PLANNING APPLICATION

PLN-HOB-2026-0060

103 SUMMERLEAS RD FERN TREE TAS 7054

REQUEST FOR INFORMATION

103 Summerleas Road Shed Proposal - Site Layout

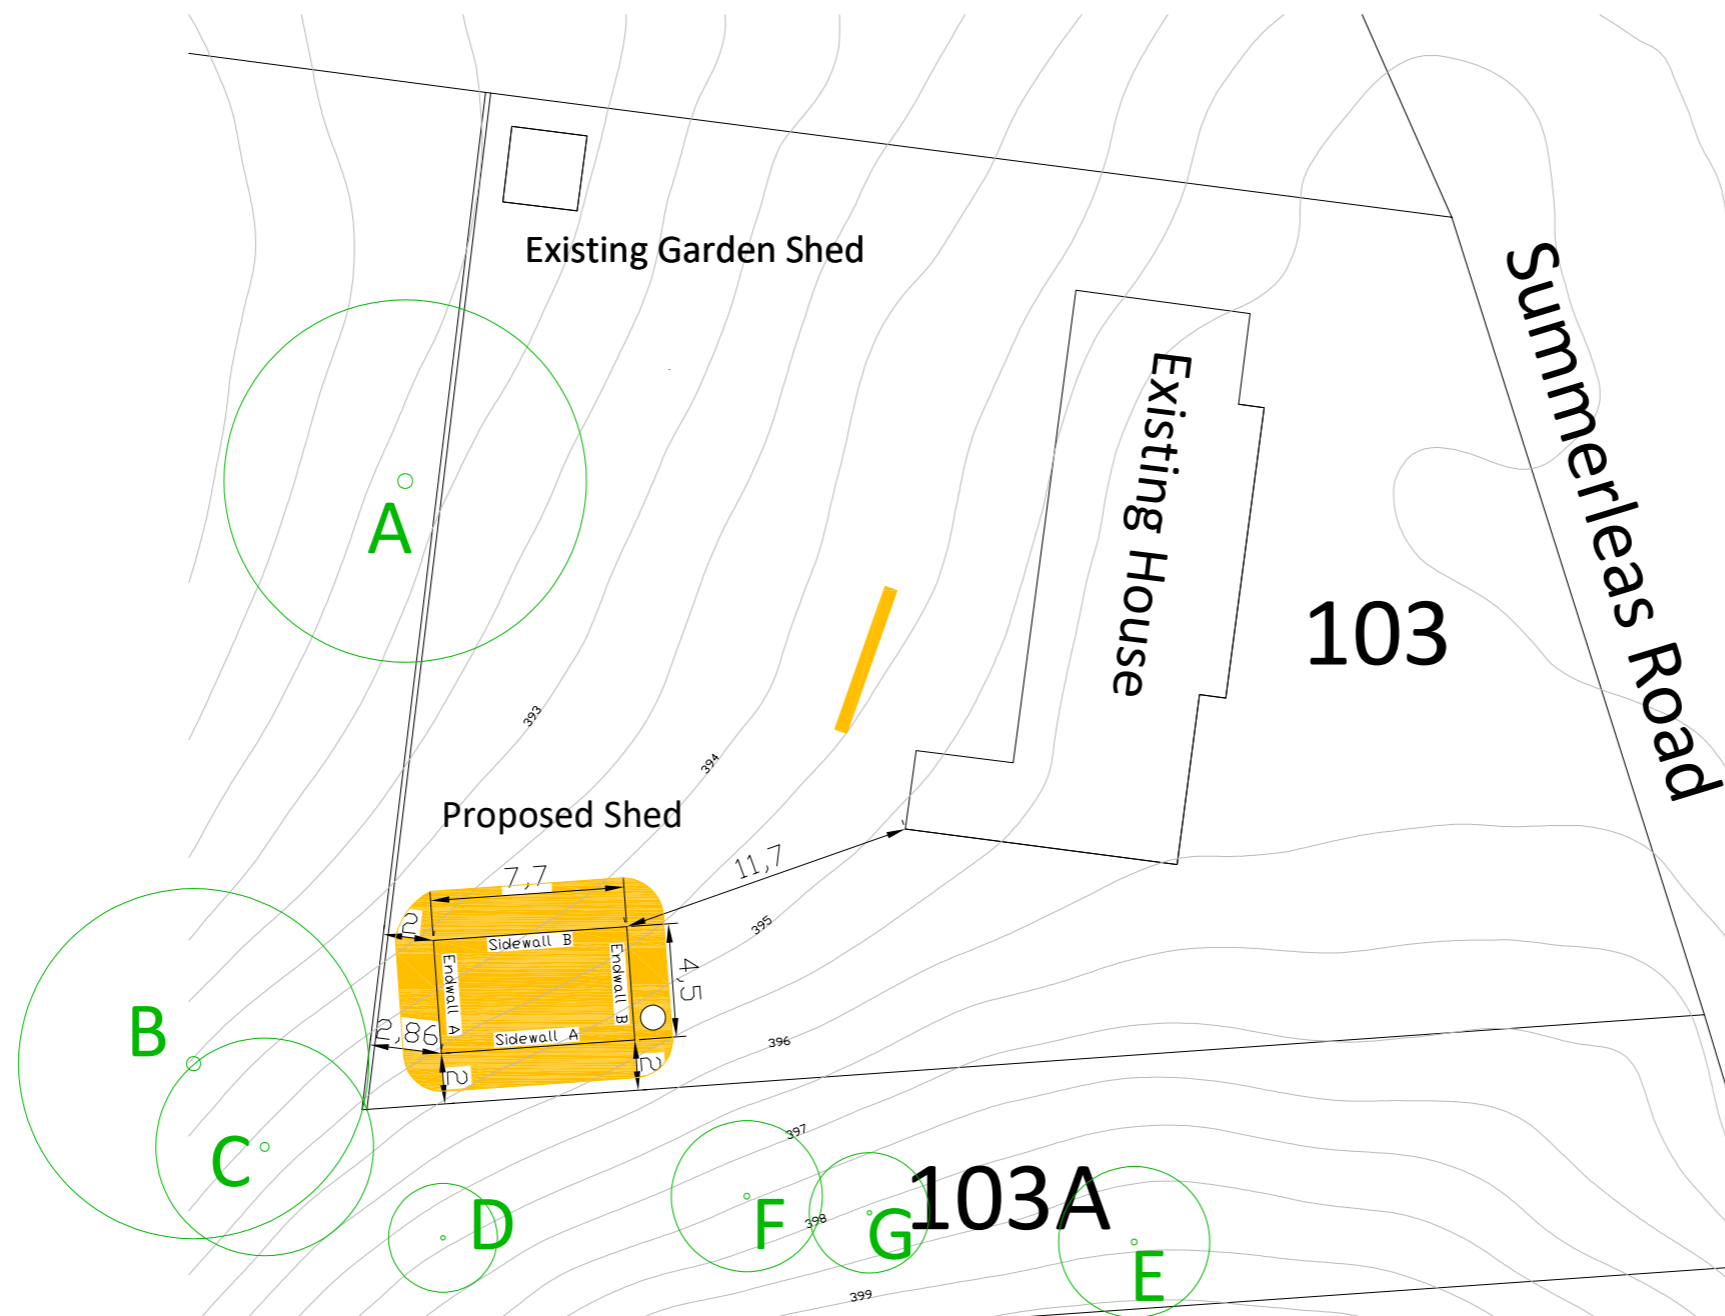
3	<p>ENV 1 - Natural Assets Code</p> <p>Please submit a scaled site plan showing:</p> <ul style="list-style-type: none"> the location of the proposed shed; the extent of proposed cut and fill or any other works associated with the proposed development (e.g. stormwater trenches); the location of any native trees on the adjacent property at 103A Summerleas Road within 8m of proposed works, and indicating the species of each tree and the trunk diameter of each tree at 1.4m above ground level; and showing the notional root zone of all native trees within 8m (radius of 12 x trunk diameter at 1.4m). 	
4	<p>C2.5.1 - Parking and Sustainable Transport Code - Car parking numbers C2.6.2 - Parking and Sustainable Transport Code - Design and layout of parking areas</p> <p>To satisfy the <i>Tasmanian Planning Scheme - State Planning Provisions</i> clause C2.5.1, please provide information sufficient to demonstrate compliance with the following;</p> <p>Please indicate whether the proposed shed is intended for vehicular use.</p> <ul style="list-style-type: none"> If the shed is intended to store or accommodate a vehicle, please include: <ul style="list-style-type: none"> Details of access requirements, such as how vehicles will enter and exit the shed. Information on any driveway extension, widening, or construction required to provide suitable vehicular access. Materials, surface type, and dimensions of the proposed accessway or driveway works. Location relative to existing driveways, road frontage, or property boundaries. <p>If the shed is not intended for vehicular use, please confirm that it is for non-vehicular purposes only (e.g., storage, workshop, garden equipment) and no vehicle access or driveway modifications are required.</p>	LUPAA 1993

A revised site plan with the requested information is provided.

Trees are shown that are within 8m of

Tree trunk diameters are shown as is the notional root zone

Estimated impacted area from shed, earthworks and stormwater level spread (garden bed) shown in yellow.
